**SOLICITATION AMENDMENT  
MODIFICATION DE L'INVITATION**

<b>Title - Sujet</b> (TPSNG2) Test Equipment	
<b>Solicitation No. - N° de l'invitation</b> W8476-195946/A	<b>Amendment No. - N° modif.</b> 002
<b>Client Reference No. - N° de référence du client</b> W8476-195946	<b>Date</b> 2019-05-23
<b>GETS Reference No. - N° de référence de SEAG</b> PW-\$\$QD-021-27266	
<b>File No. - N° de dossier</b> 021qd.W8476-195946	<b>CCC No./N° CCC - FMS No./N° VME</b>
<b>Solicitation Closes - L'invitation prend fin</b> <b>at - à 02:00 PM</b> <b>on - le 2019-07-05</b>	
<b>Time Zone</b> <b>Fuseau horaire</b> Eastern Daylight Saving Time EDT	
<b>F.O.B. - F.A.B.</b> Specified Herein - Précisé dans les présentes <b>Plant-Usine:</b> <input type="checkbox"/> <b>Destination:</b> <input type="checkbox"/> <b>Other-Autre:</b> <input checked="" type="checkbox"/>	
<b>Address Enquiries to: - Adresser toutes questions à:</b> Abdulkadir, Nadir	<b>Buyer Id - Id de l'acheteur</b> 021qd
<b>Telephone No. - N° de téléphone</b> (819) 420-5861 ( )	<b>FAX No. - N° de FAX</b> ( ) -

## **Bidders' Conference Questions and Answers**

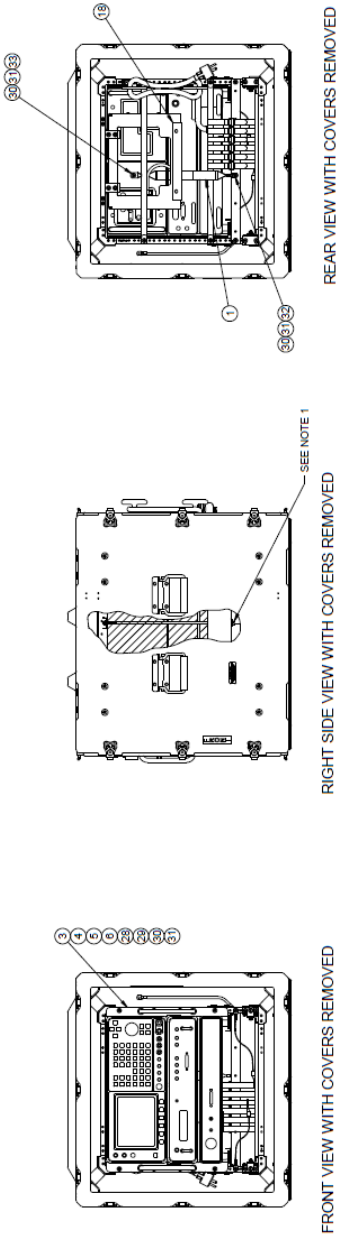
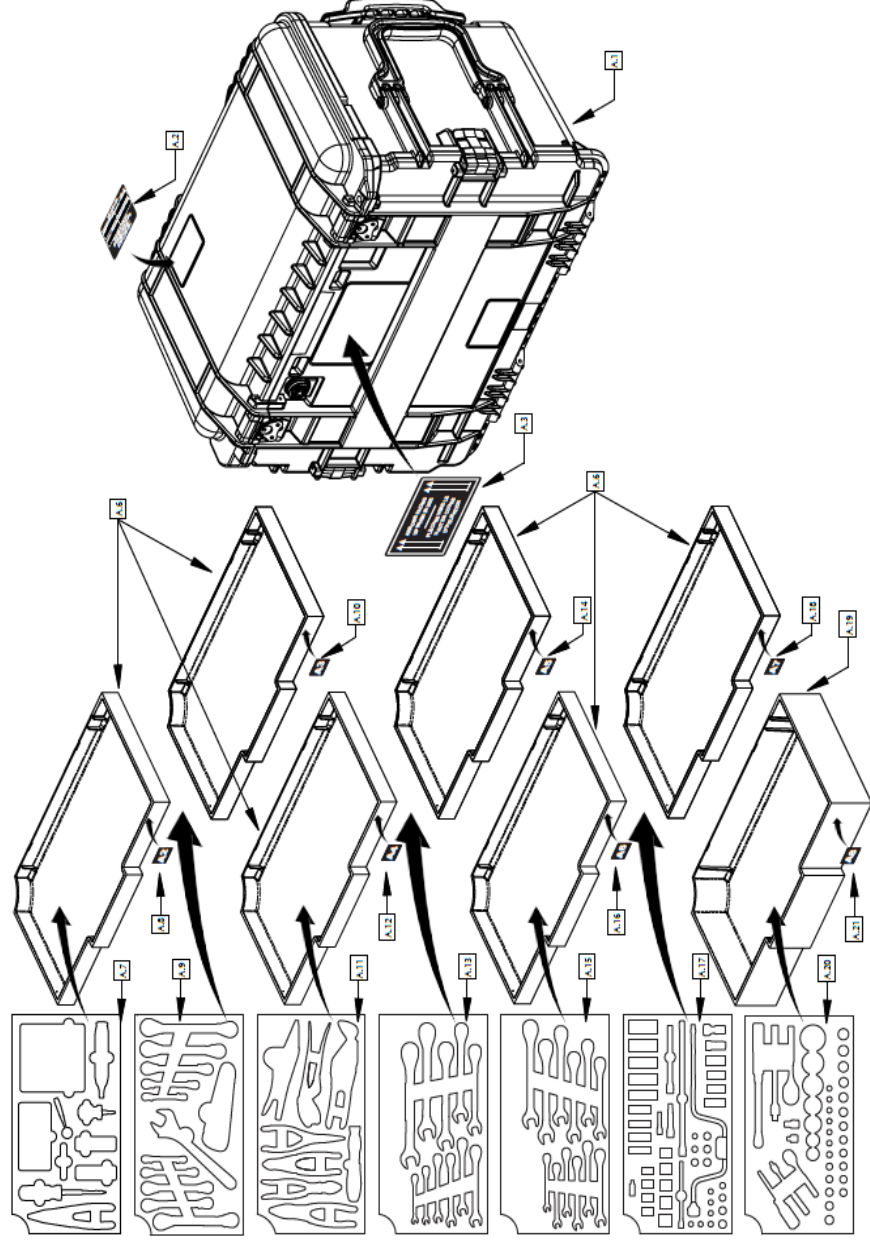
Is it possible to have a photograph of a TPSNG (V2) configured in the Equipment Cases?

Below is a photograph of the GFE items as they were presented at the Bidders' Conference. The photograph shows the TPSNG (V2) test equipment installed in the Equipment Cases. A LESv2 is shown on top of the upper-left equipment case, and a CSB with test cables connecting it to the SCCD, is shown beneath the keyboard on the upper-right equipment case.
